Turkey Point 2017-301

Post Exam Comments

1) Applicant Comment (Q89)

TELETYPE ENGINEERING SERVICES

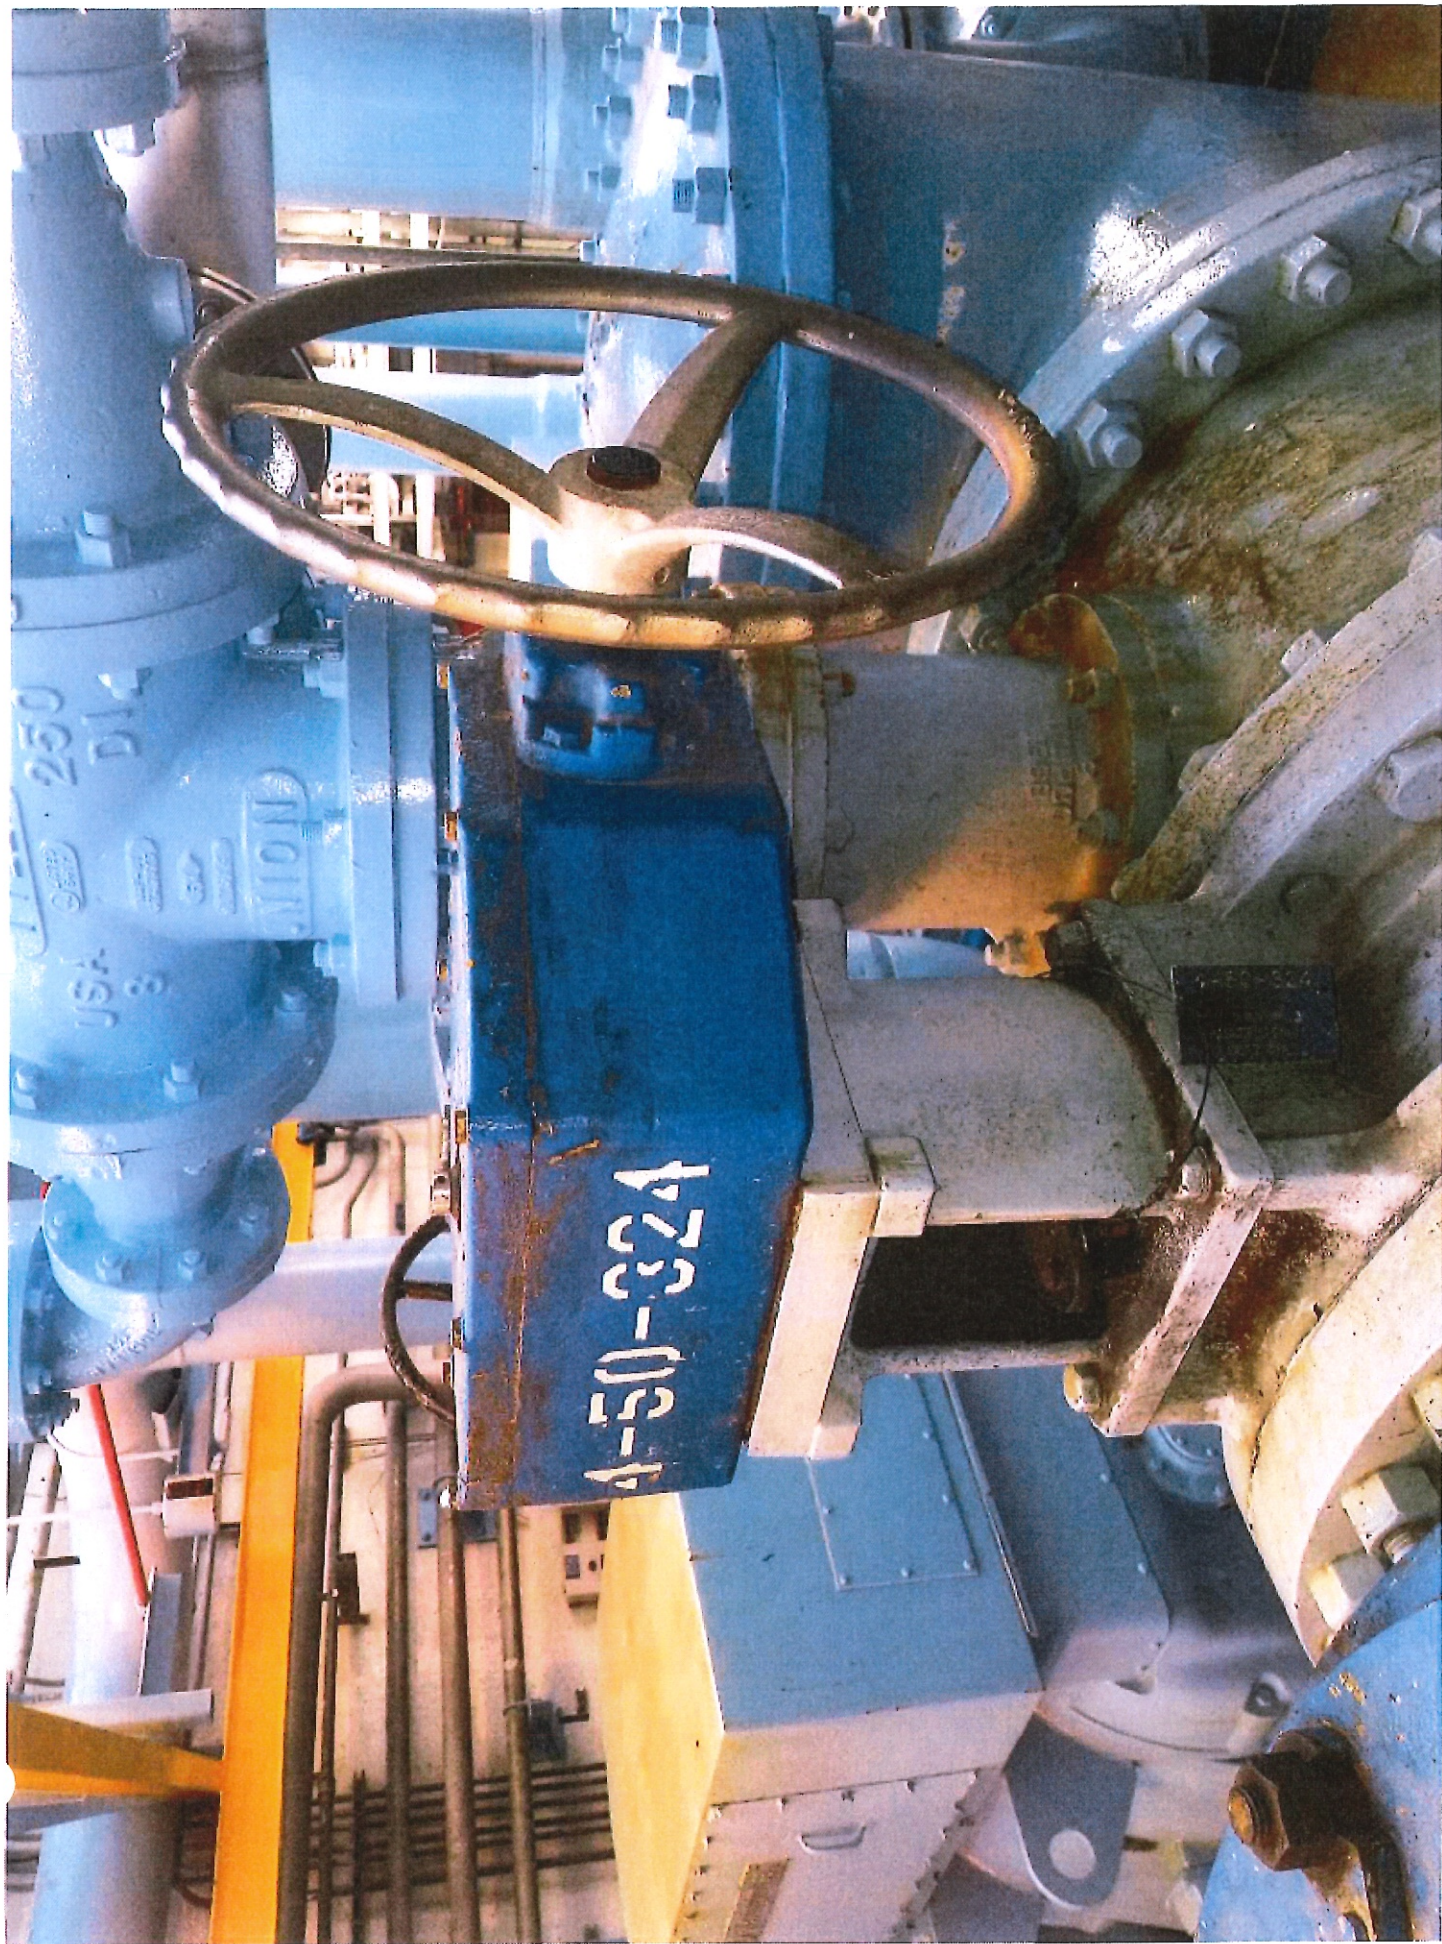
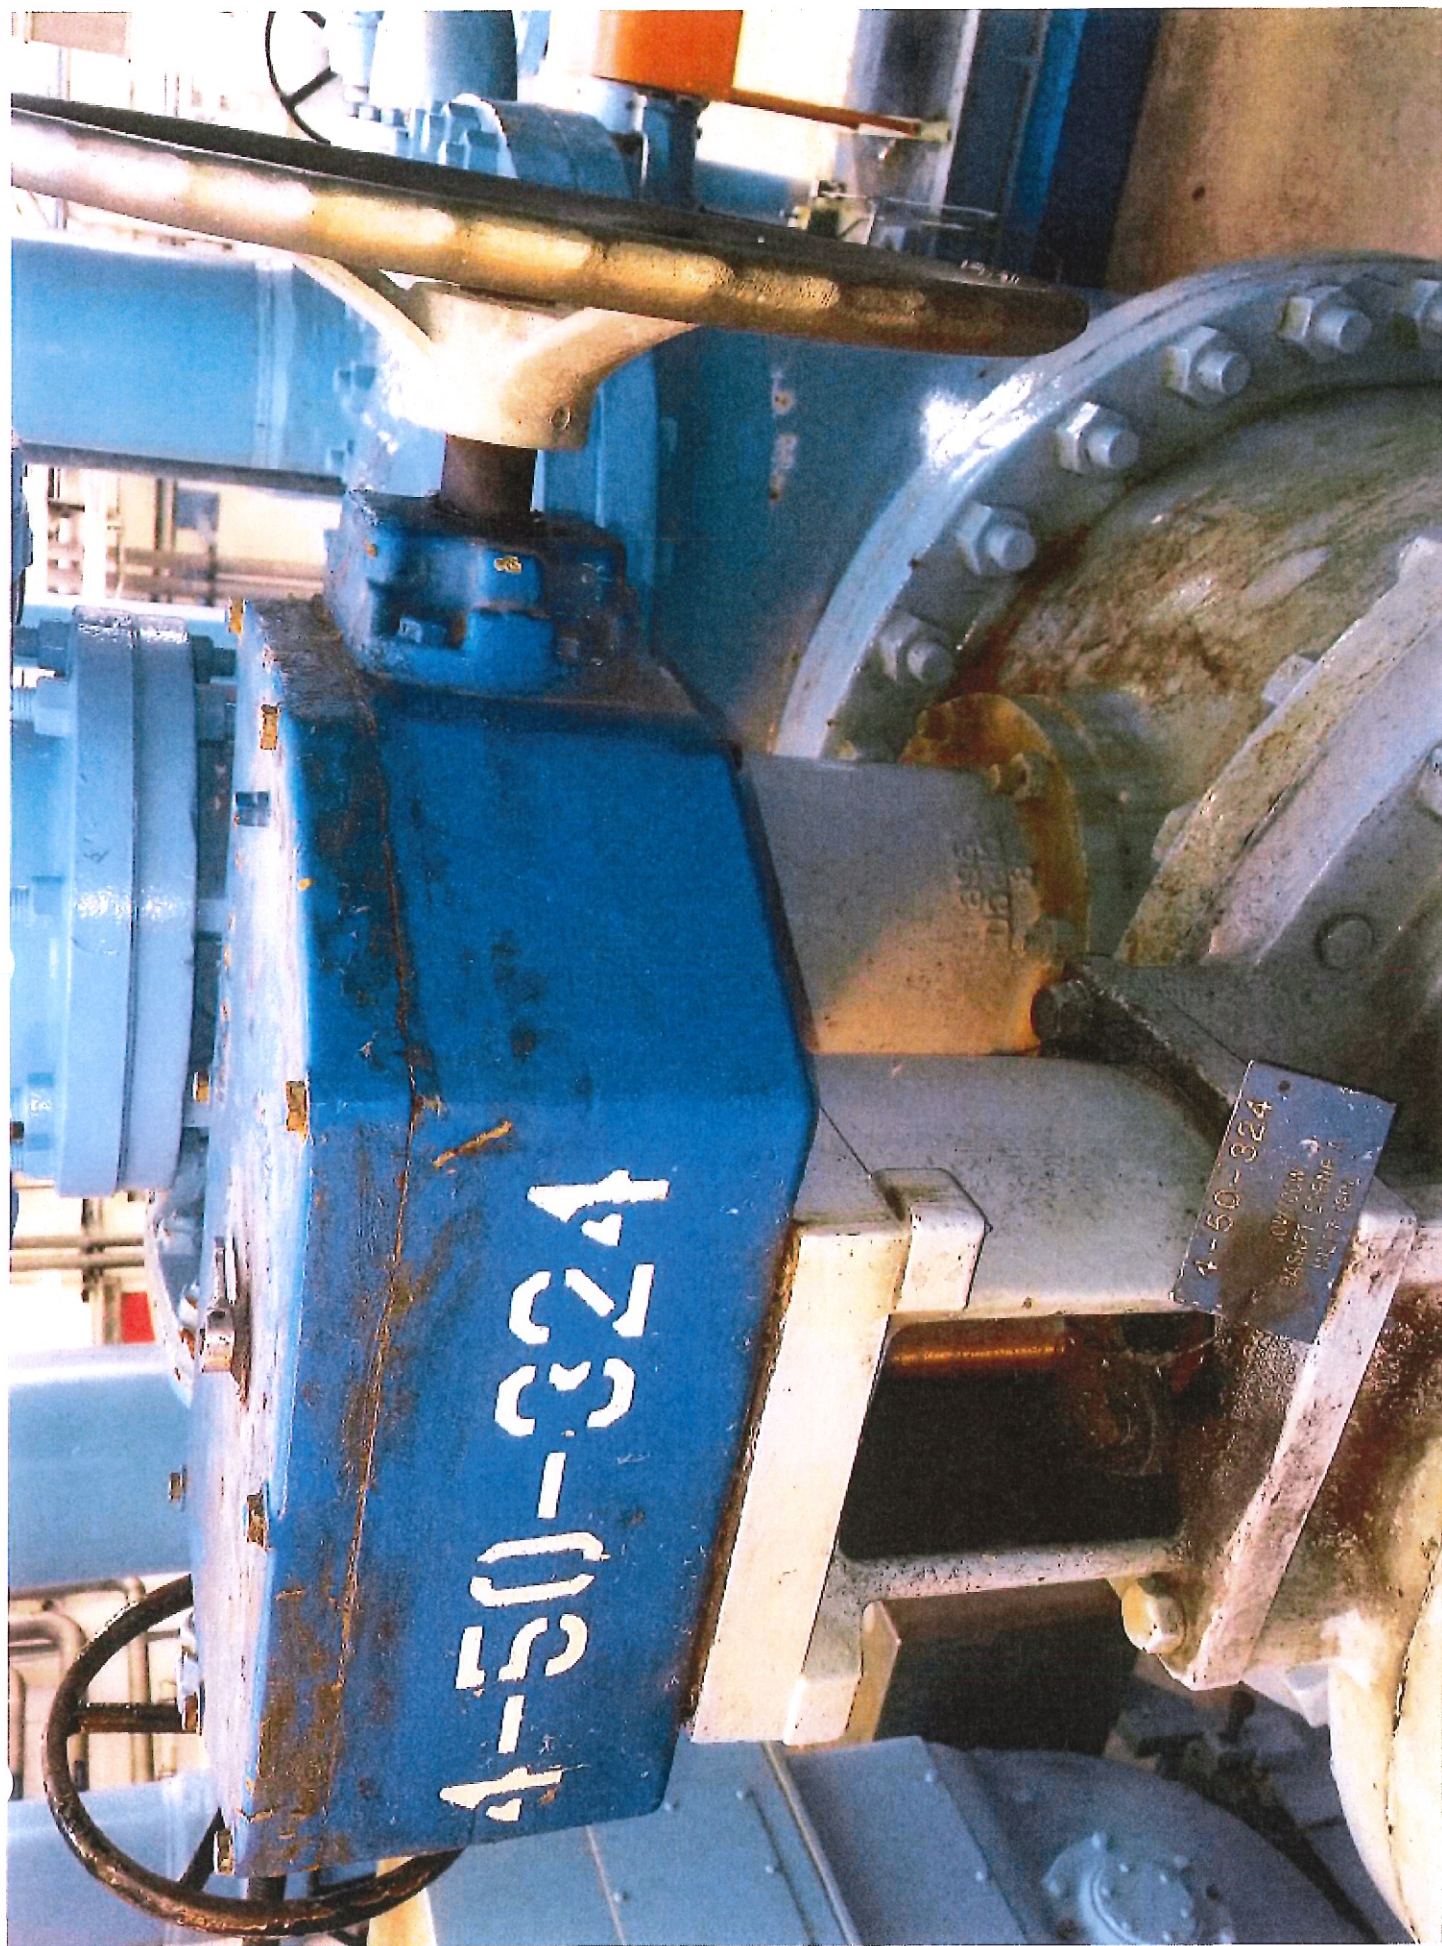
The Initial Conditions/Stem of the question state that valve 4-50-324 has a sheared pin and the valve remains closed. However, there is no definitive indication about time, which leaves the applicant to determine if the valve can be opened within 5 minutes to comply with Limitation 2.2.3.3. Indications show that the valve's pin has sheared (handwheel spins freely) and the valve remains closed. Valve 4-50-324 is a manual operating valve and has no other means to operate the valve in the open direction. See attached P&ID, isometric drawing, and picture of valve 4-50-324.

The Initial Conditions/Stem of the question state that valve 4-50-324 has a sheared pin and the valve remains closed. However, there is no definitive indication about time, which leaves the applicant to determine if the valve can be opened within 5 minutes to comply with Limitation 2.2.3.3. Indications show that the valve's pin has sheared (handwheel spins freely) and the valve remains closed. Valve 4-50-324 is a manual operating valve and has no other means to operate the valve in the open direction. See attached P&ID, isometric drawing, and picture of valve 4-50-324.

Facility Position on Applicant Comment on question 89: FPL concurs with the applicant's position on deletion of question 89.
